MIL-S-19500/321A
AMENDMENT 3
19 September 1978
SUPERSEDING
AMENDMENT 2
17 September 1975

MILITARY SPECIFICATION

SEMICONDUCTOR DEVICE, DIODE, SILICON, MIXER

TYPES 1N21WG, 1N21WGM, AND 1N21WGMR

FIGURE 1. Semiconductor device, diode, types 1N2lWG, 1N2lWGM, and 1N2lWGMR.

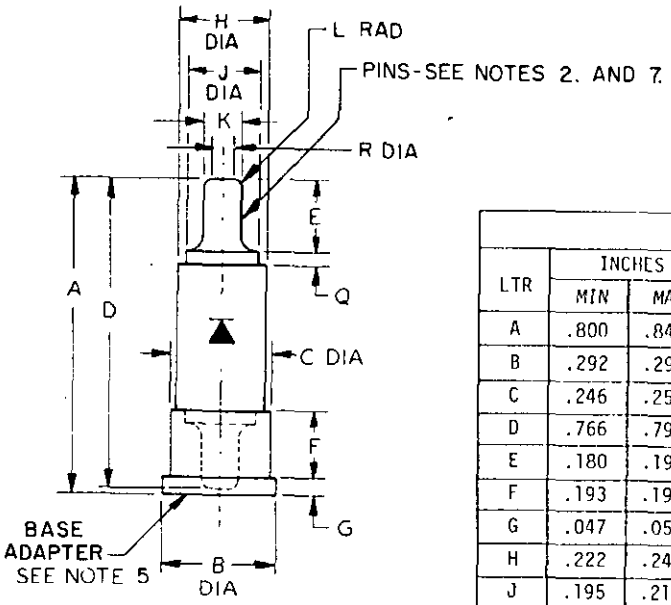
FIGURE 1: Delete and substitute new figure 1 as printed on page 2 of this amendment.
